**KNOXVILLE/KNOX COUNTY METROPOLITAN PLANNING COMMISSION  
SUBDIVISION REPORT - CONCEPT/USE ON REVIEW**

▶ **FILE #:** 8-SE-09-C  
8-J-09-UR

▶ **SUBDIVISION:** SHERRILL HILL  
▶ **APPLICANT/DEVELOPER:** KINGSTON PIKE, LLC  
**OWNER(S):** Raymond A. Higgins

▶ **PROPOSED USE:** Planned Commercial Subdivision

CP0.03

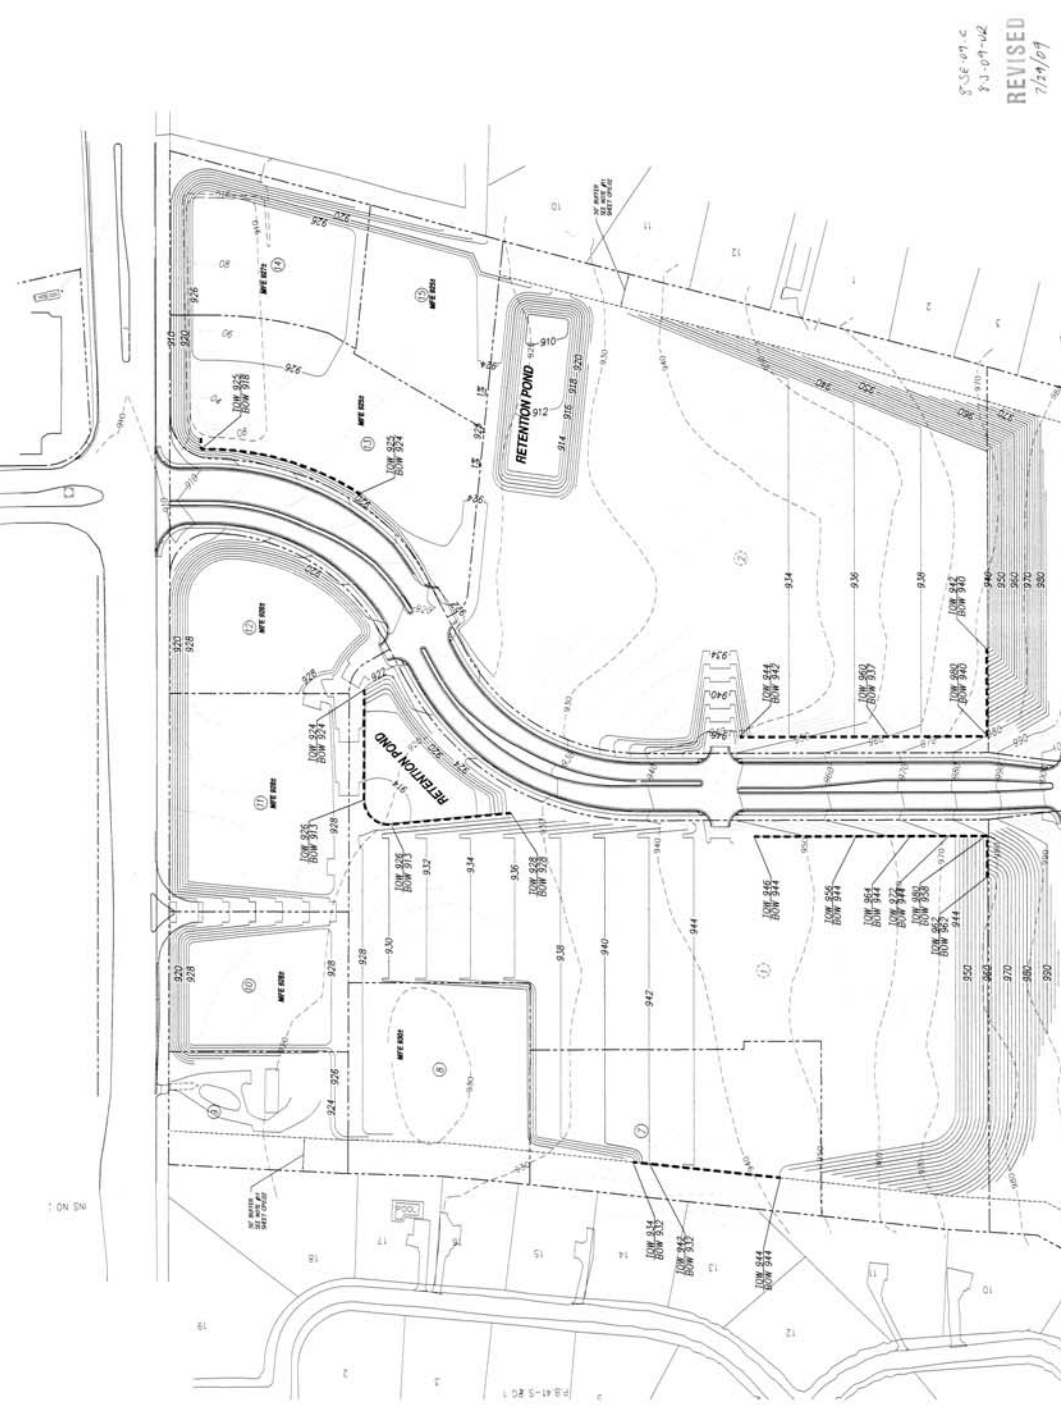
11. Revising the concept plan to extend the access easement to Lot 14.
12. Meeting all applicable requirements of the Knoxville Zoning Ordinance.
13. A final plat application based on this concept plan will not be accepted for review by the MPC until certification of design plan approval has been submitted to the MPC staff and documentation has been provided that the driveways located within the access easements that serve the lots have been installed in compliance with the approved design plan.
